HATFIELD BOROUGH PLANNING COMMISSION

FEBRUARY 27, 2023

PLANNING COMMISSION February 27, 2023 7:00PM AGENDA

Hatfield Borough Review Letters

DRAWN BY: CRK DATE: 12-08-2022
CHECKED BY: KWC DRAWING NO.: 20005
JOB NO.: 20005 SHEET 1 of 12

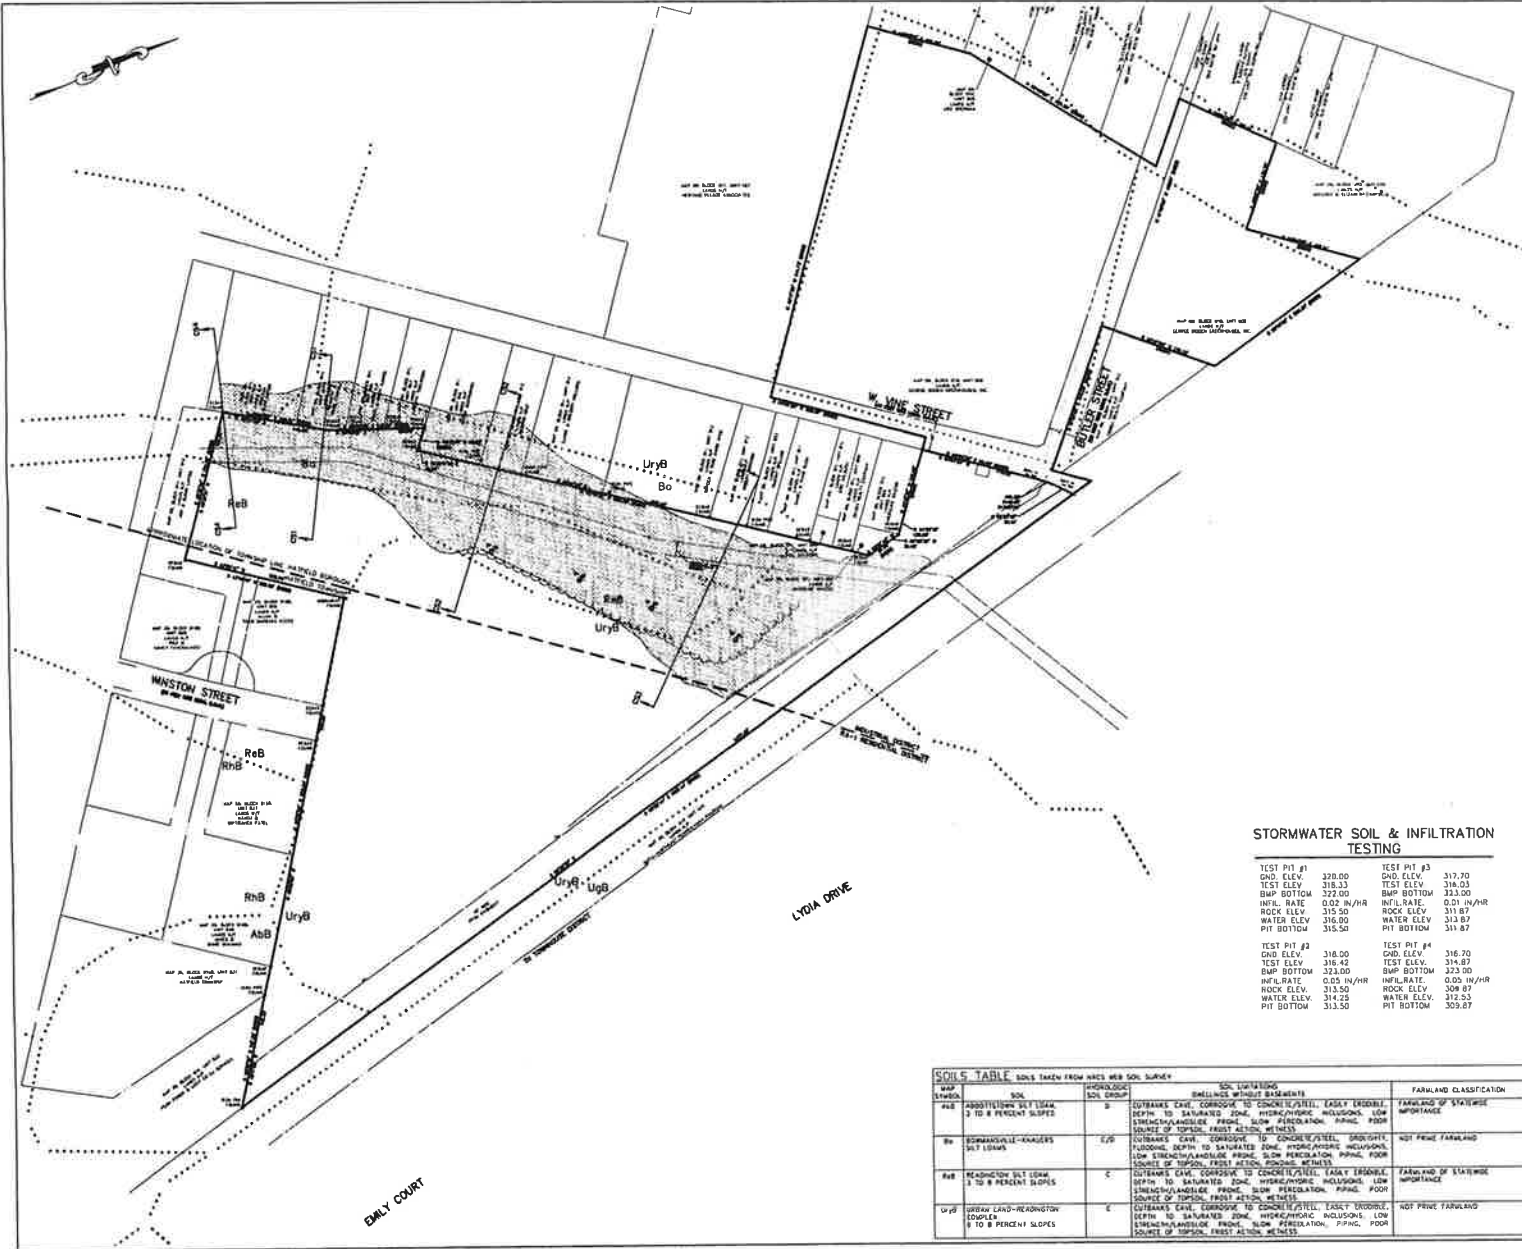
1. The applicant applied for and was granted several variances from the Zoning Hearing Board from the following Zoning Ordinance sections, as summarized on Sheet 1 of 12:
 - a. 282-24 (Use regulations), to allow the proposed use. The land development plan notes the proposed use as "Manufacturing / warehouse wholesale business / agriculture."
 - b. 282-27.A (Building coverage), to allow building coverage in excess of 20% allowed, not to exceed 57%. The land development plan identifies the proposed building coverage as 52%.

3. Nine parking spaces are proposed based upon nine employees noted on Sheet 1 of the plan. The Applicant should confirm the number of employee work shifts for the facility. If greater than one, the required parking must be calculated using the two heaviest work shifts. (282-186.B.11)

9. General Note 6 on Sheet 1 references public water service to the site. The plans illustrate an incoming water line from the Winston Street cul-de-sac. Fire hydrants, existing and proposed should be shown. (250-35)

- ii. Calculations for minimum required Net Land Area landscaping are based on “Developable area in Hatfield Township” as listed under “Site Info” on Sheet 1, Land Development Plan, which is acceptable. The calculations should be adjusted to exclude building area. (250-38.C.2)

DESIGN BY: CRK	DATE: 12-08-2022
CHECKED BY: KWC	DRAWING NO.: 20005
JOB NO.: 20005	SHEET: 3 OF 12

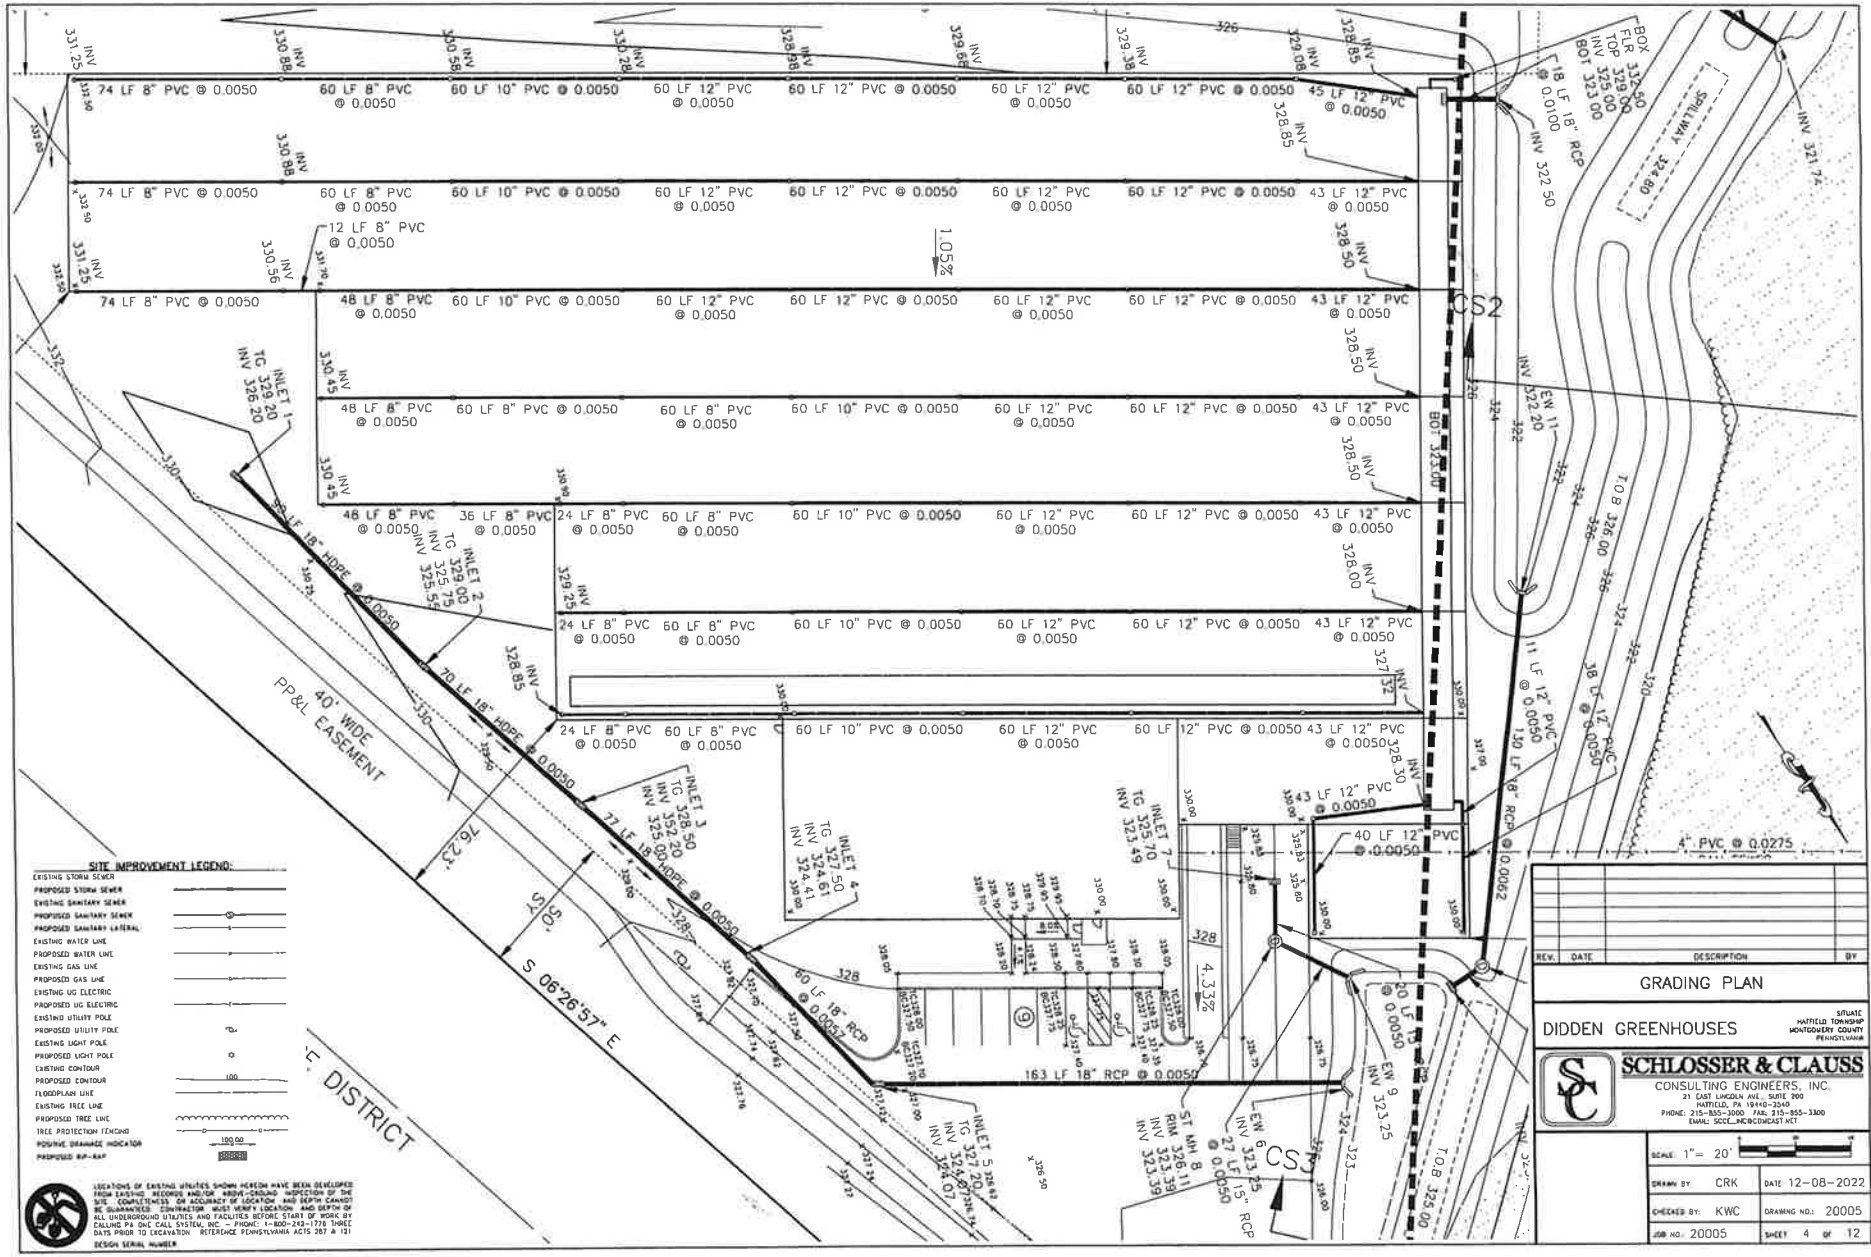
- g. The four-inch perforated PVC within the forebay/rain garden detail on Sheet 11 of 12 should be shown in plan view.
 - h. The invert in for Inlet 3 noted on Sheet 3 of 12 is not consistent with consistent with the profile on Sheet 8 of 12.

- k. The basin's emergency spillway width should be dimensioned in plan view on Sheet 3 of 12 and the crest length / invert must be consistent between the plan detail and Stormwater Report.

- m. It is not clear if the Trash Rack Detail on Sheet 10 also applies to Outlet Structure # 1 within the forebay.
 - n. The proposed curbing should be tapered where it terminates in the vicinity of Inlet 4; TC/BC elevations should be noted on Sheets 3 and 4 of 12 and a typical detail added to Sheet 9 of 12

SCALE	AS NOTED
DRAWN BY:	CRK DATE: 12-08-2022
CHECKED BY:	KWC DRAWING NO.: 20005
JOB NO.:	20005 SHEET 9 OF 12

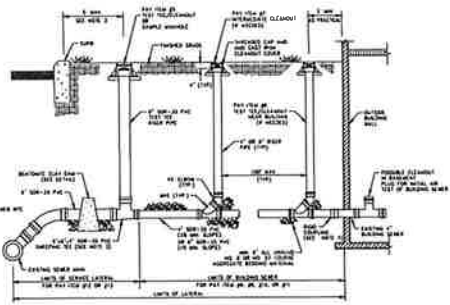
- o. Curbing and inlet(s) should be considered along the driveway / loading area to prevent vehicle damage to forebay berm.
 - p. Sidewalk shall have cross slope for drainage. The detail on Sheet 9 of 12 should be revised. (250-31.l)
